Access Compliance Report Public Rights-of-Way (Pedestrian Signals)

Intersection ID: N/A	Main Street:	Cross Street: N/A	Location: N/A
ADA ID: D4E8BF27EE25	Signal Type: One Push Button-Non APS	Overall Compliance: No	Severity Score: BTN 1: N/A BTN 2: N/A No BTN: N/A
Codes/Mitigation Info/Possible Solution		Field Measurements/Component Compliance

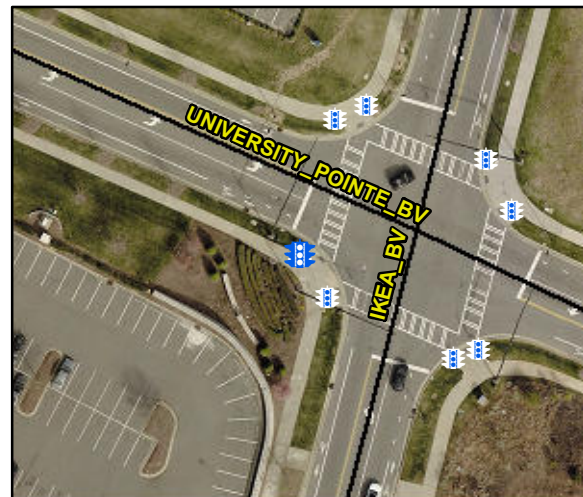
Possible Solutions: Replace Signal Push Button With APS Button on New Post. Remove & Relocate Sign.

PROW/ADA: TMUTCD 4e.08, R404.2, R404.3, R404.7.2
